Product Change Notification (PCN)

| PCN Number | 506696 | Date Issued | January 21, 2019 |

- «21x21» metal bulkhead mounting housing right angle.

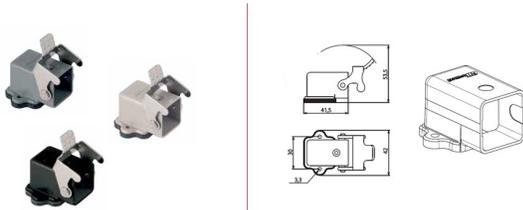
| Change Type Description | This letter is to inform you that another set of tooling is being added to meet the current and future demands of this product. There will be no changes in the fit, form or function from the additional tooling when compared to the current tooling. | | |

- This document is to inform you that Molex HDC is going to replace the mould for «21x21» metal bulkhead mounting housings with right angle.
- The picture on the left represents the involved products.
- See attached impacted parts list.
- This is part of our consolidated process of maintaining the operations. The new mould will create less waste than the current one which is getting closer to the end of the shelf life.
- Form, fit & function of the product won't be affected.
- Qualification Reports and samples will be available upon request after the date shown above.
